AGENDA
PLANNING AND ZONING COMMISSION MEETING
CITY OF CREVE COEUR, MISSOURI
MONDAY, APRIL 21, 2014
7:00 PM

#14-009 APPROVAL OF AN AMENDMENT TO THE SITE CONCEPT PLAN FOR MISSOURI BAPTIST UNIVERSITY AND SITE DEVELOPMENT PLAN APPROVAL OF A FOOTBALL PRACTICE FIELD, STUDENT HOUSING AND EIGHT-FOOT TALL FENCING AROUND A MAINTENANCE YARD

REQUEST: Approval of the design for the Practice Field Locker Room Facilities. During the March 31st Planning and Zoning Commission meeting, the members approved the new site concept plan for Missouri Baptist University and the site development plan for the new football practice field in the southwest corner of the campus and Phase III of the Spartan Village student housing complex, as well as an eight-foot tall fence around the maintenance yard in the southeast corner of the campus, subject to the conditions listed in the Staff Report dated March 27, 2014.

Drawn:
Checked:
Drawing No.
A2.1
Practice Football Field

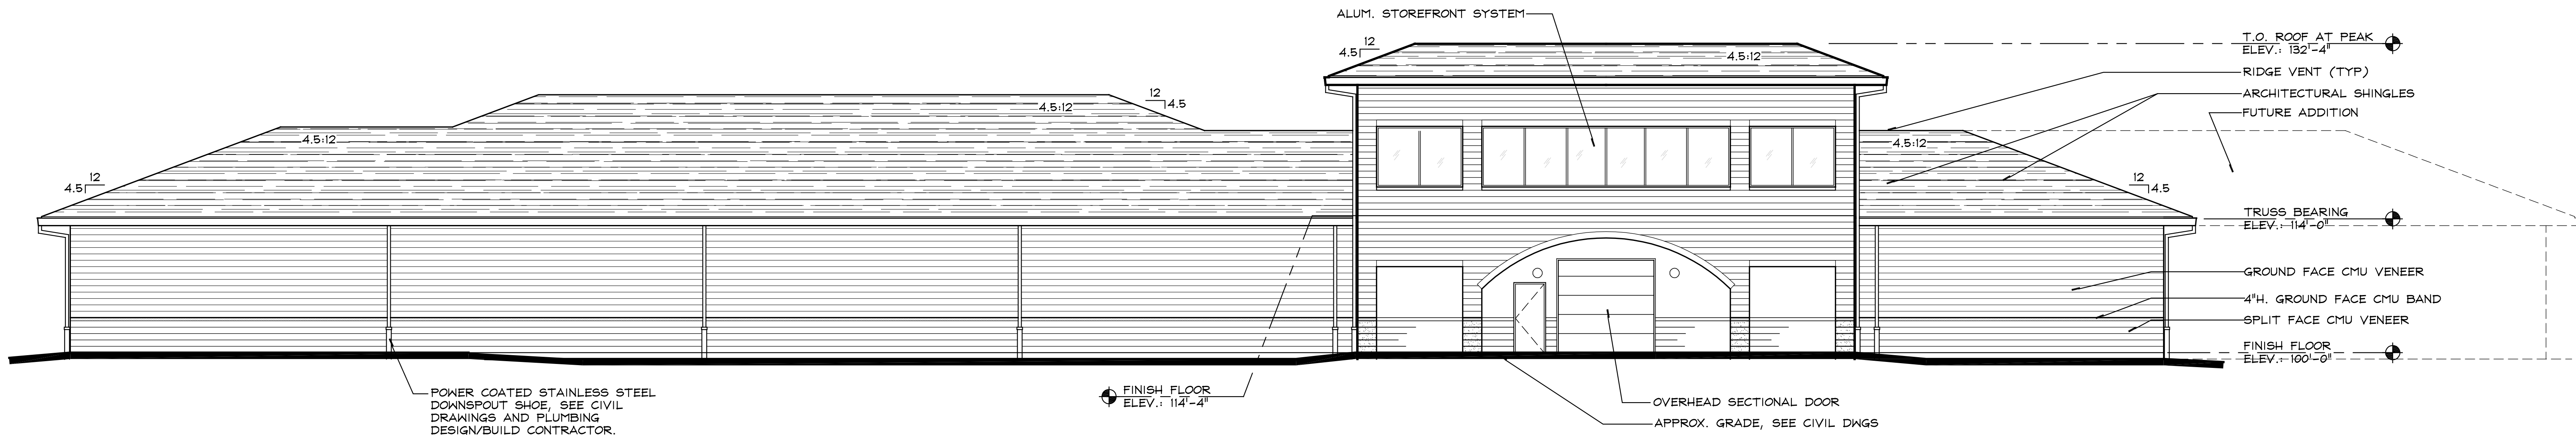
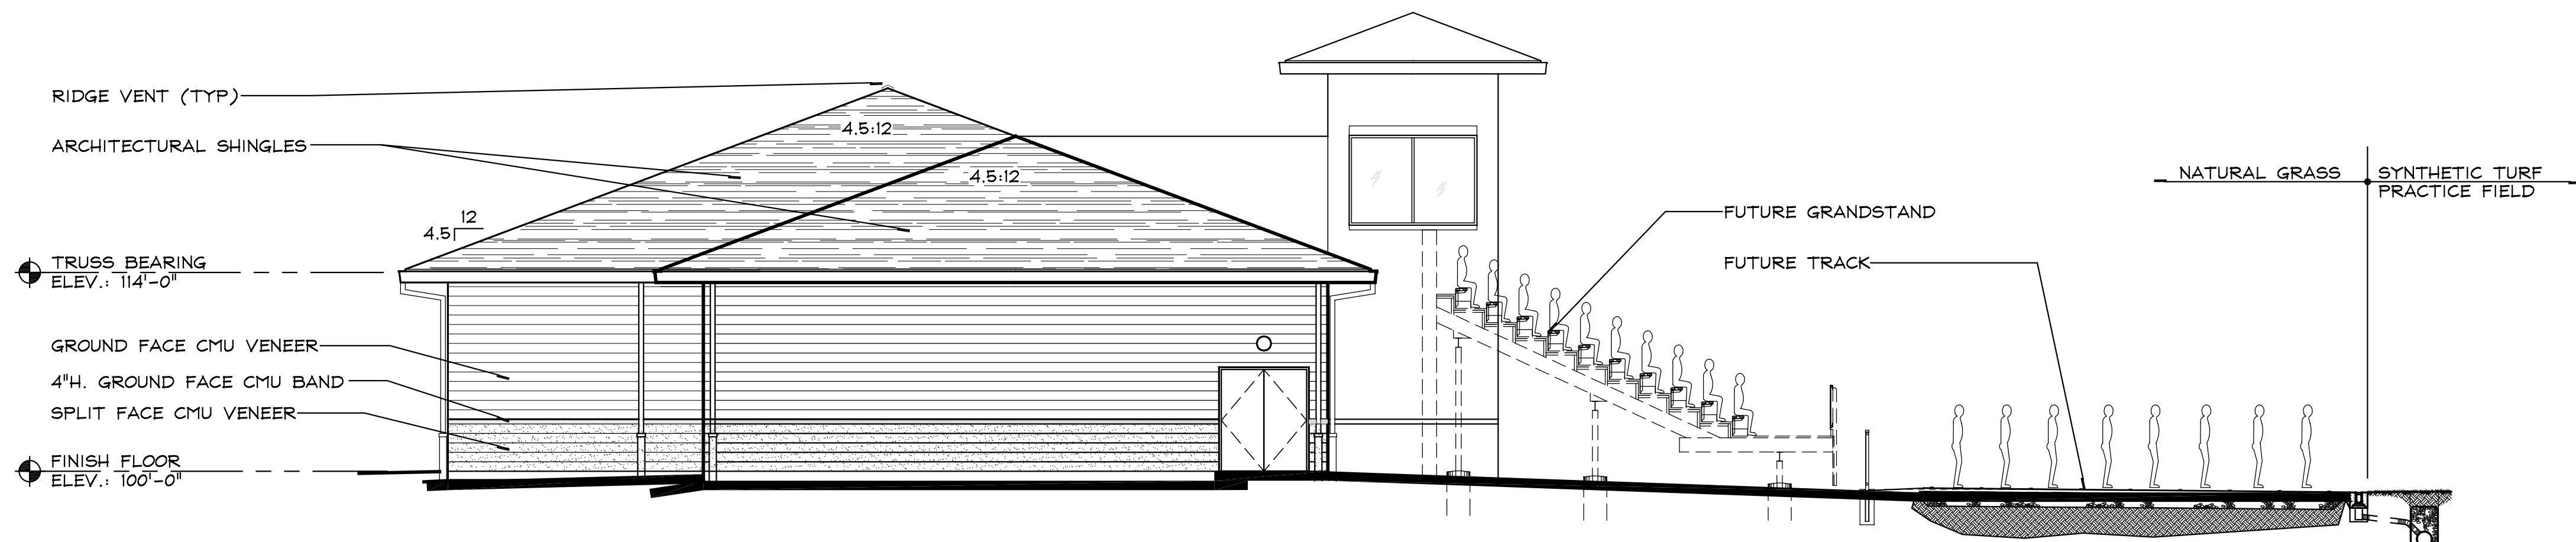
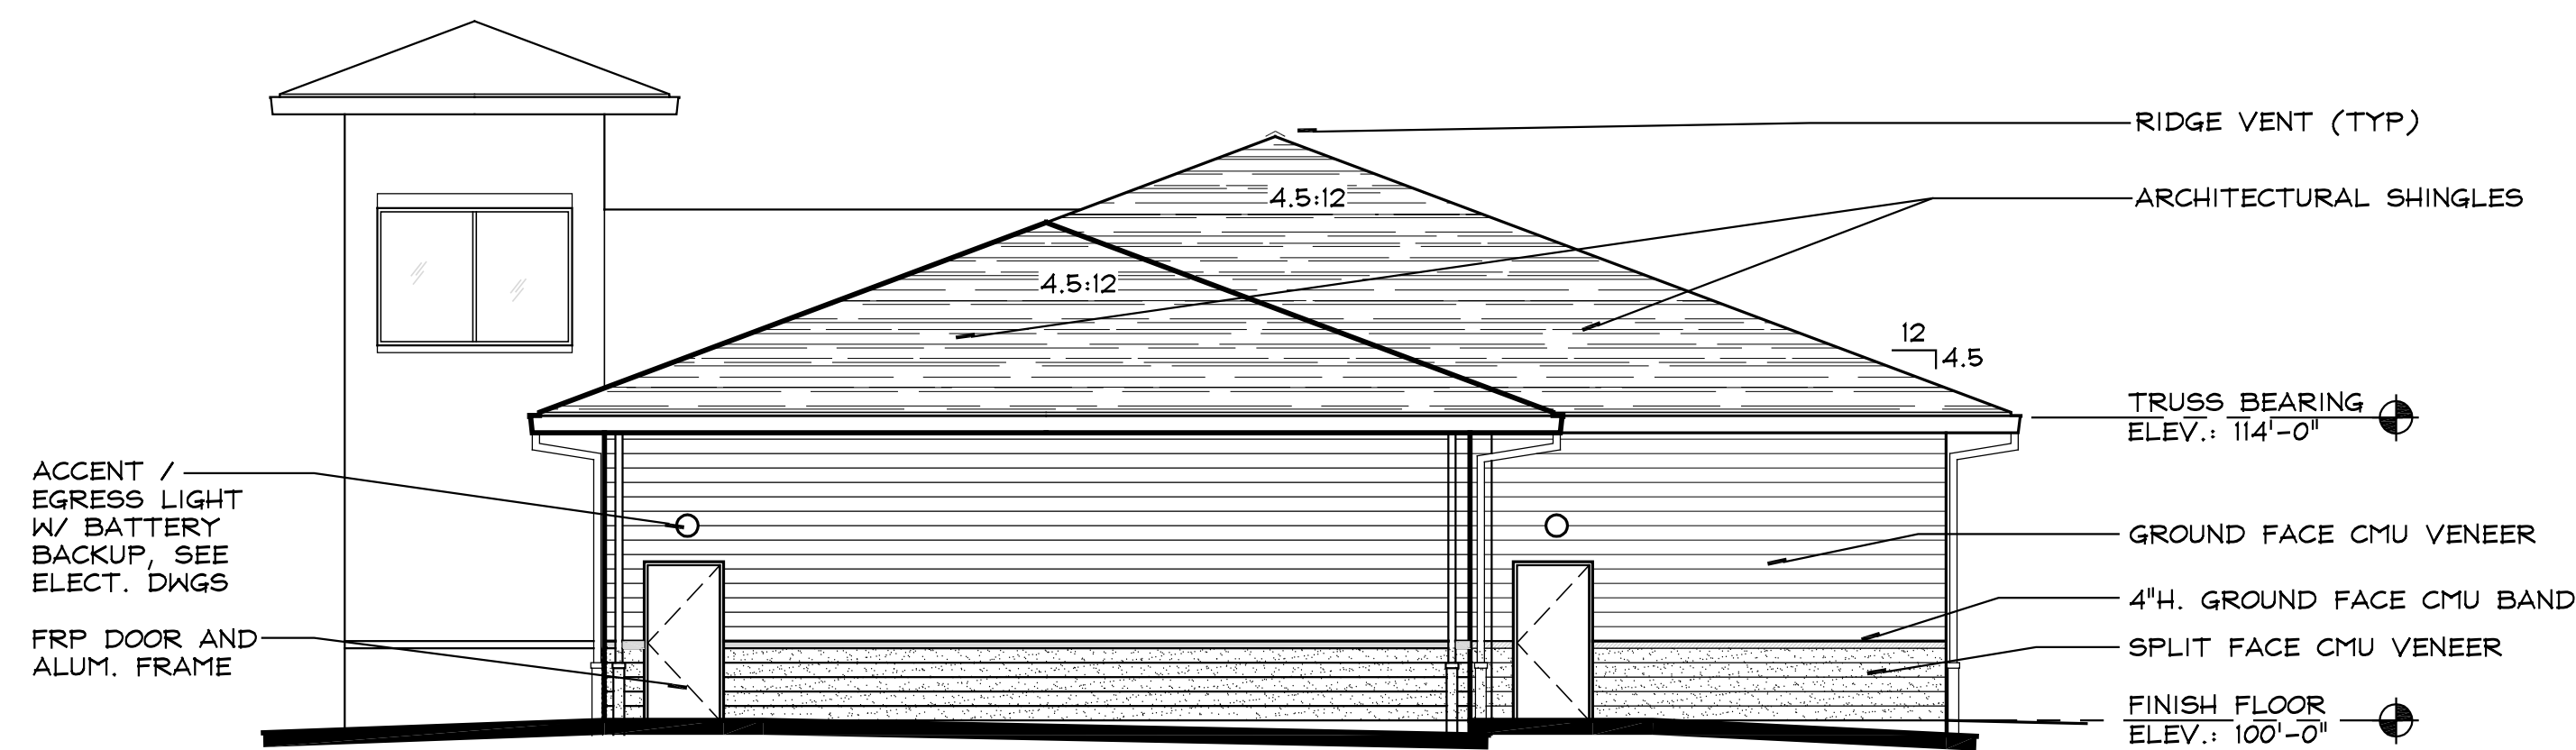
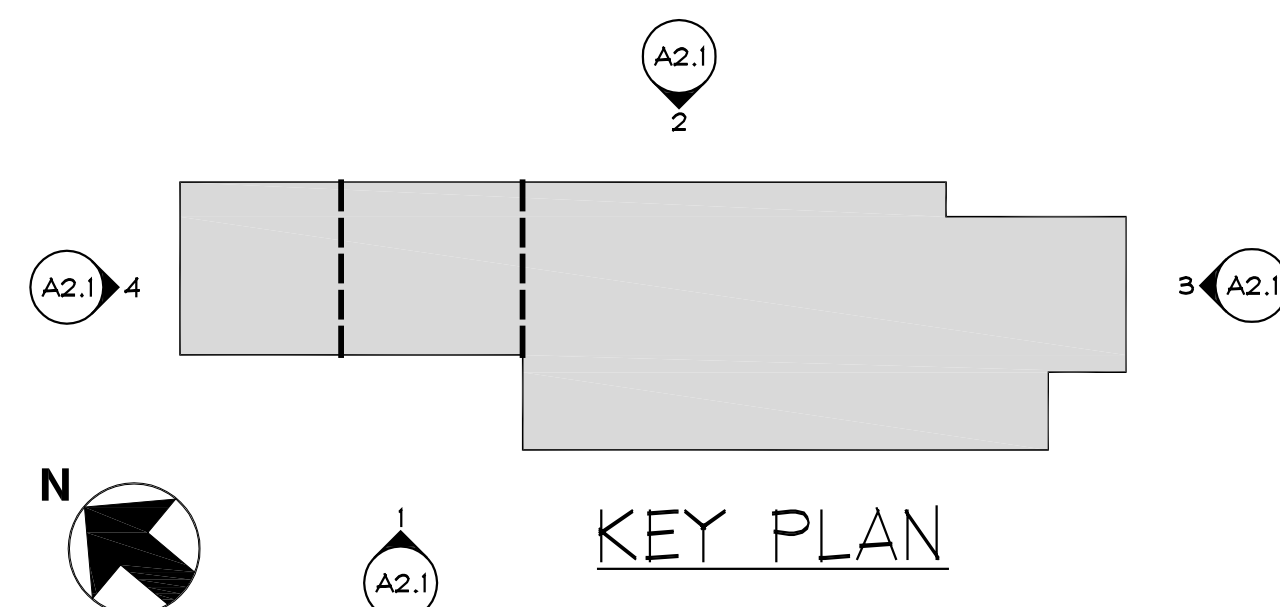
ADDITIONAL INFORMATION: The only remaining issue was the design of the Locker Room Building. The Planning Commission members asked that the Applicant revise the drawings of the proposed Locker Room Building adjacent to the new practice field so that it would meet with the Design Guidelines. The redesign of the facility includes a hip roof design and greater architectural interest, with split face CMU and ground face CMU veneer along all sides of the building.

The revised drawings addressed the concerns raised in the prior staff report and include larger windows, and the buildout of the press box. The building is more thought out in design and architecturally consistent on all sides, with a greater degree of pedestrian scale and interest. The Applicant has not selected a color for the masonry materials at this time, therefore, Staff has included a condition of approval that the color shall be architecturally consistent with the themes on the rest of the campus, and shall not be painted. The future bleachers will provide screening of the rear elevation, and the lack of window on the right and left is largely due to the function and privacy needs of the locker rooms.

If the members of the Planning Commission believe that the revised locker room design has addressed the issues that were raised in the prior report and that the remaining issues can be addressed at the staff level, the approval should be subject to the following conditions:
